**DEPARTMENT OF PLANNING AND
COMMUNITY DEVELOPMENT**

CASE NO.: 04-CUP-010 (Lighting Plan)

REQUEST: Request for approval of an exterior lighting plan for a medical office building.

VERSALUX

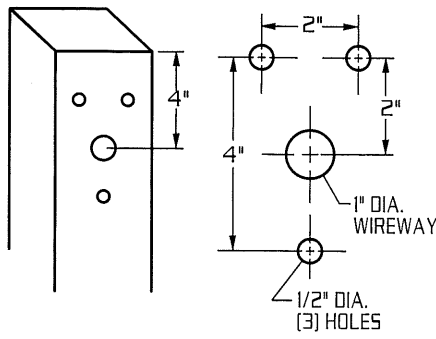
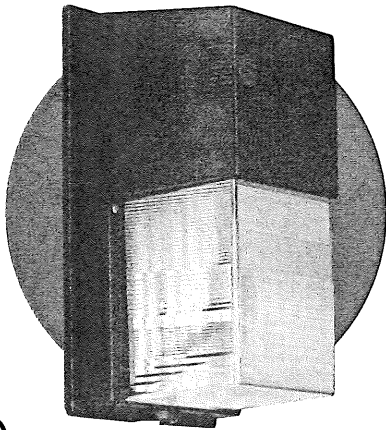
lot. Each proposed fixture is rectangular in shape with a metal highland cutoff lens that is flush with the bottom of the fixture. All proposed fixtures and support poles include a bronze finish that is intended to be compatible with the building, as called for in the City Lighting Guidelines. If the Planning Commission desires a more decorative fixture to serve the project, staff recommends that it be subject to approval by the Director of Planning and Community Development. Staff also recommends that based on recent direction given by the Planning Commission for parking lot light fixtures, that the cement mounting base of each fixture pole be stained in a color approved by the Director of Planning and Community Development. The maximum height allowed by the City for each fixture, including the mounting base, is 16 feet.

8. The parking lot light poles and fixtures shall not exceed 16 feet in height, including the mounting base. The cement mounting base shall be stained in a color approved by the Director of Planning and Community Development.
9. The proposed wall-mounted light fixtures at the garage entrance are not approved. Alternate light fixtures to serve the garage entrance area shall be subject to approval by the Director of Planning and Community Development.

WALL MOUNT

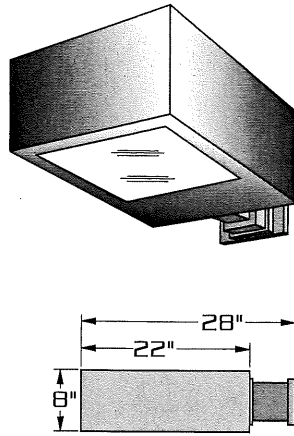
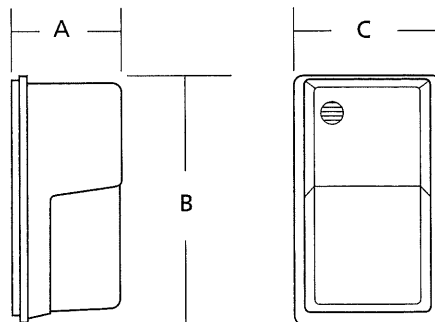
Two metal halide wall-mounted lamps are proposed above the underground garage entry, at the southeast corner of the building. The project conditions of approval state that wall-mounted lights are discouraged but may be considered by the Planning Commission upon review of a lighting fixture detail plan and photometric plan. Although staff supports the request for lighting at the garage entrance, it is recommended that the applicant consider alternate sconce lighting that is shielded to a greater extent to avoid horizontal glare, which may be visible from the Canwood Street and the neighboring property to the east. The Lighting Guidelines specifically state that "lights must be shielded to avoid glare and light spillover onto adjacent properties, the natural environmental and onto public right-of-way areas." If the Planning Commission desires the applicant to select an alternate light fixtures for the garage entry area, staff recommends the fixtures be subject to approval by the Director of Planning and Community Development.
